**PRELIMINARY/FINAL DRAINAGE REPORT  
FOR  
TIMBER RIDGE WEST**

**January 2019**  
*Revised February 2019*

TNE Job No. 1752.00  
County Job No. EA-1895

### PROPOSED DRAINAGE MAP

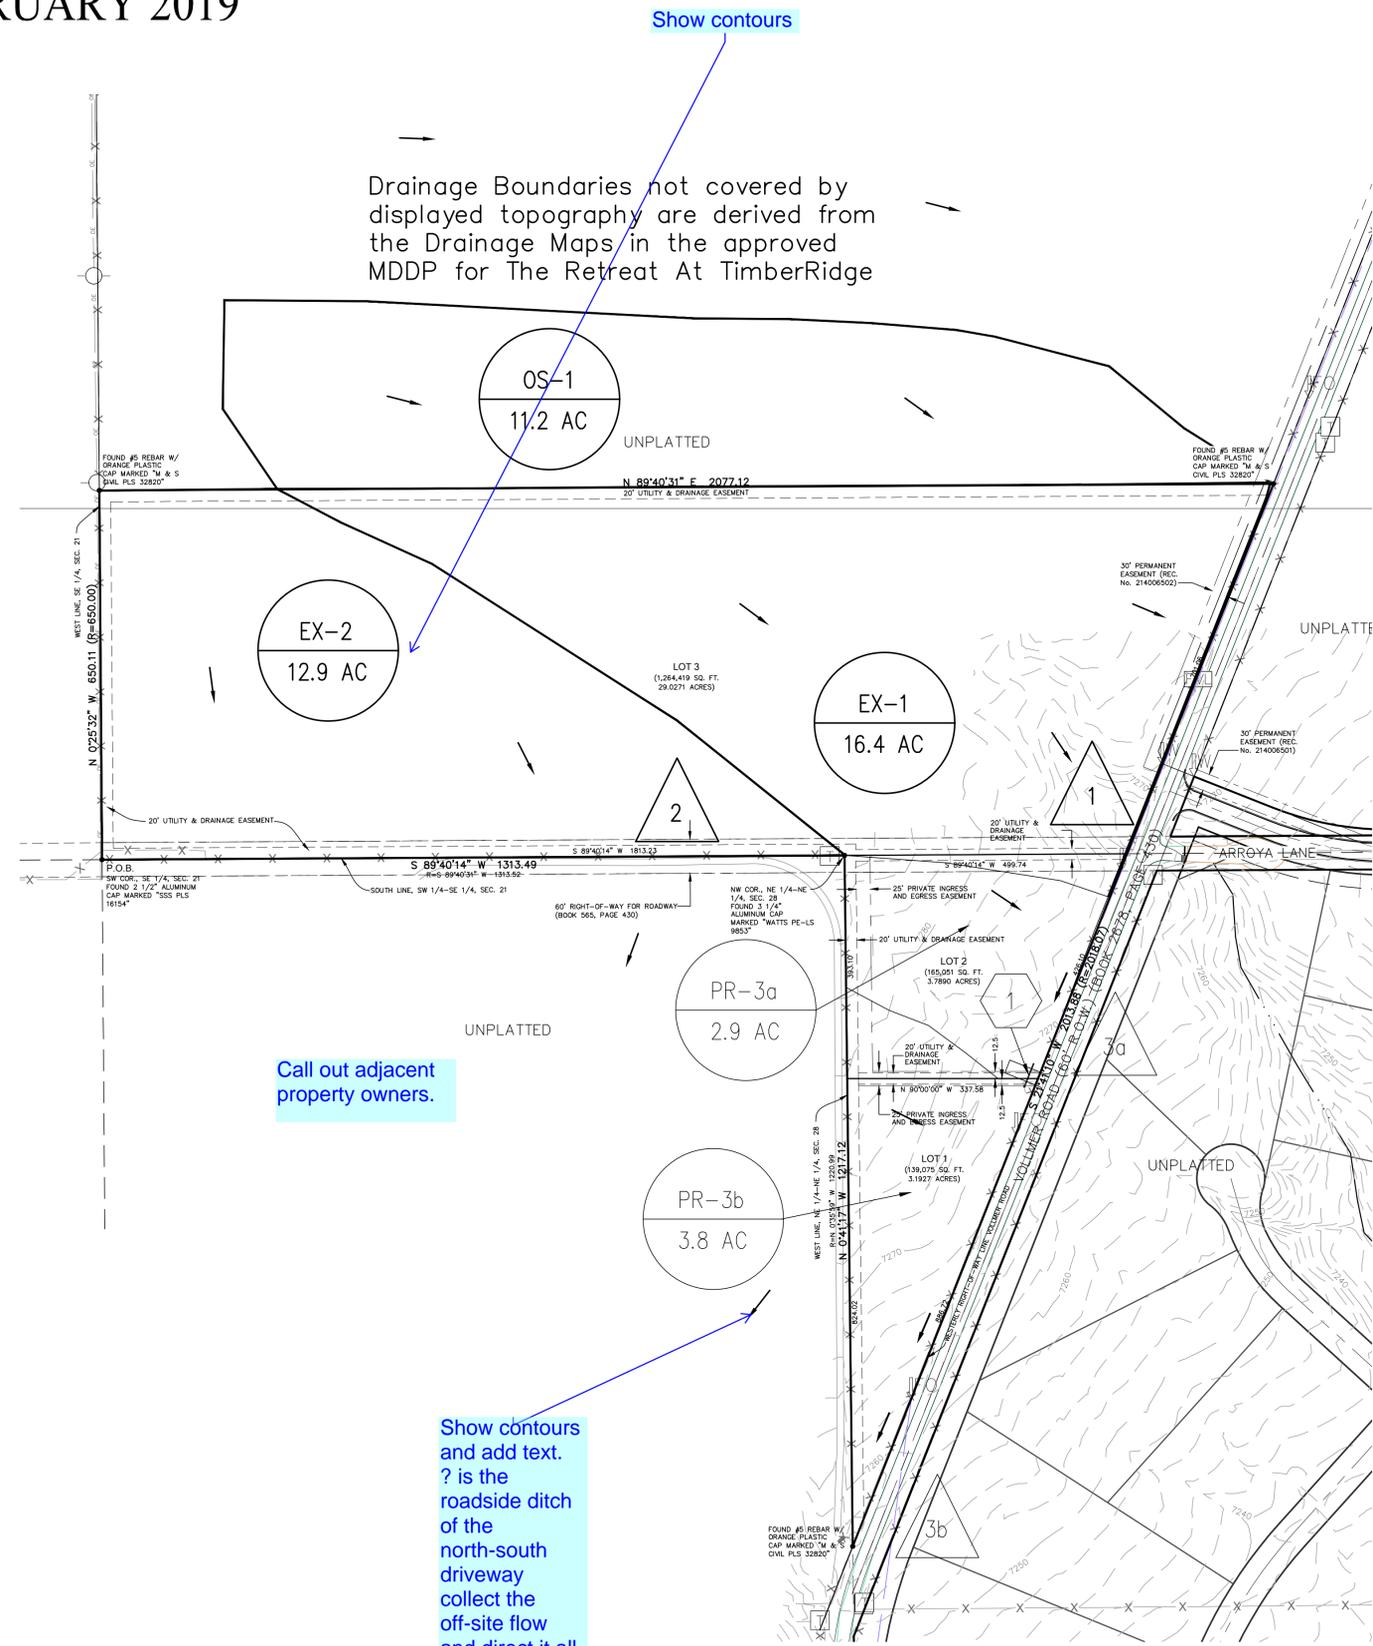
Call out adjacent property owners.

Show contours

Show contours and add text. ? is the roadside ditch of the north-south driveway collect the off-site flow and direct it all to the west?

# Timber Ridge West

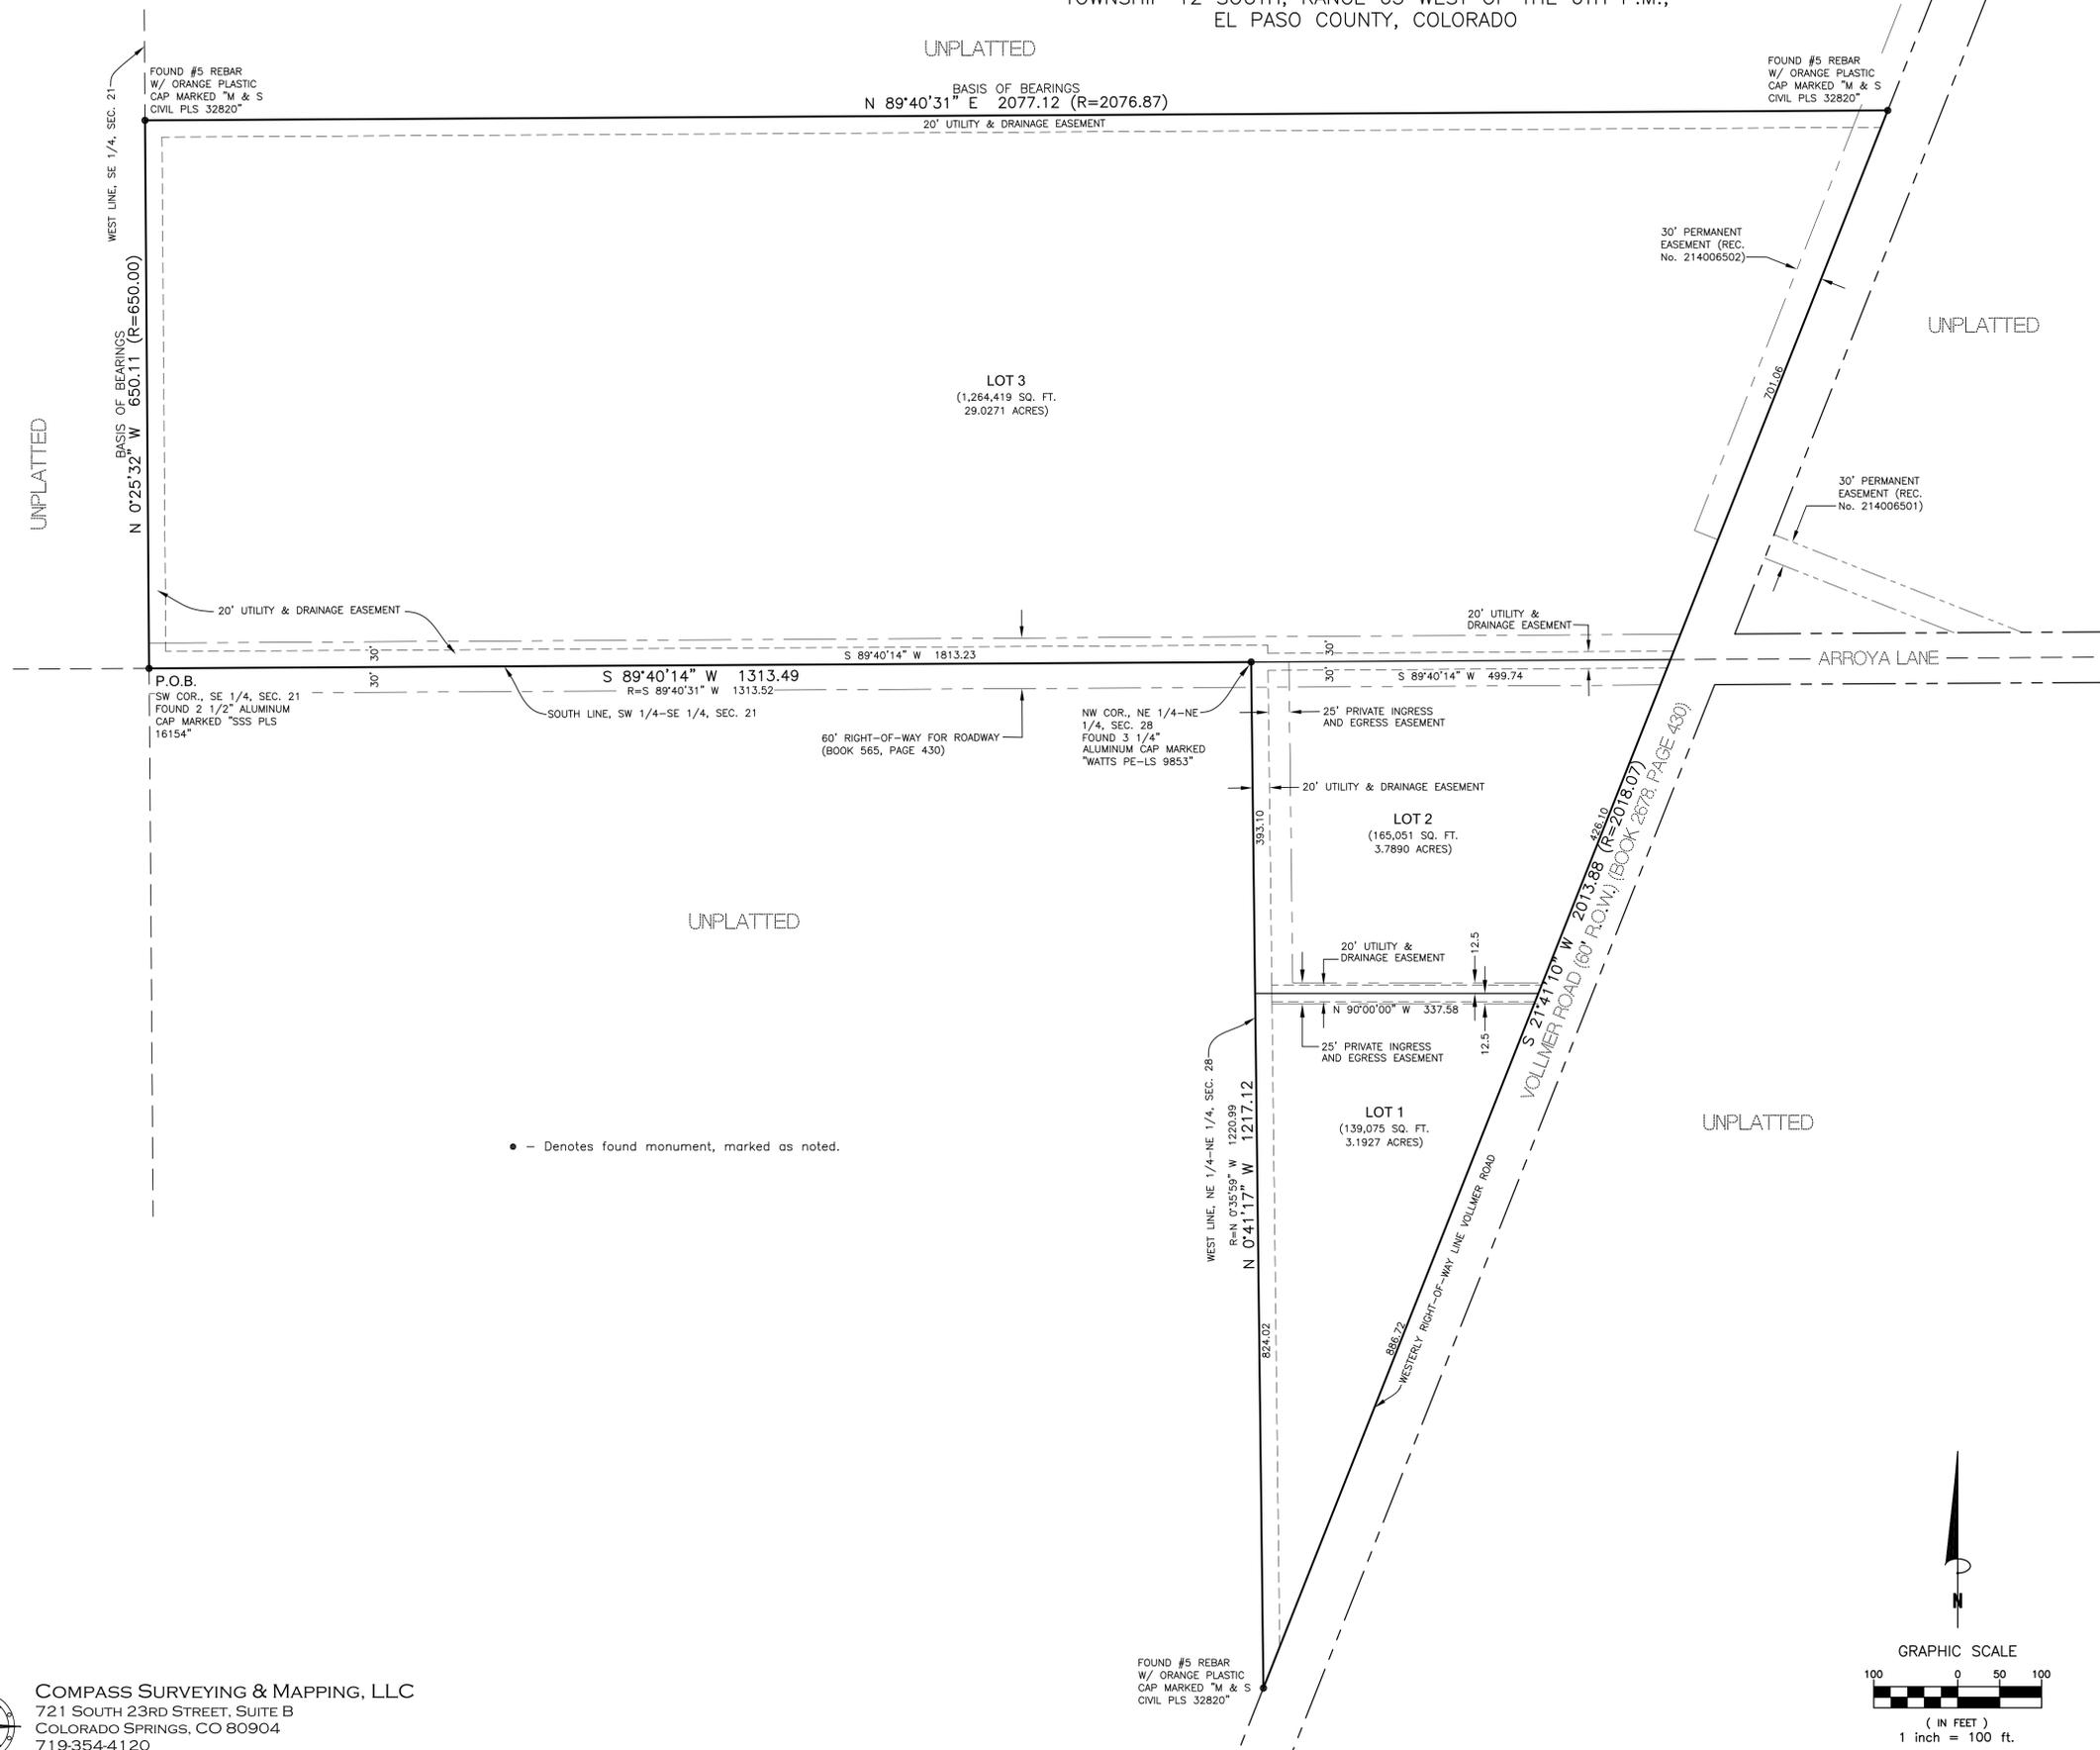
if the plat is included in the Drainage report then update according to the comments.
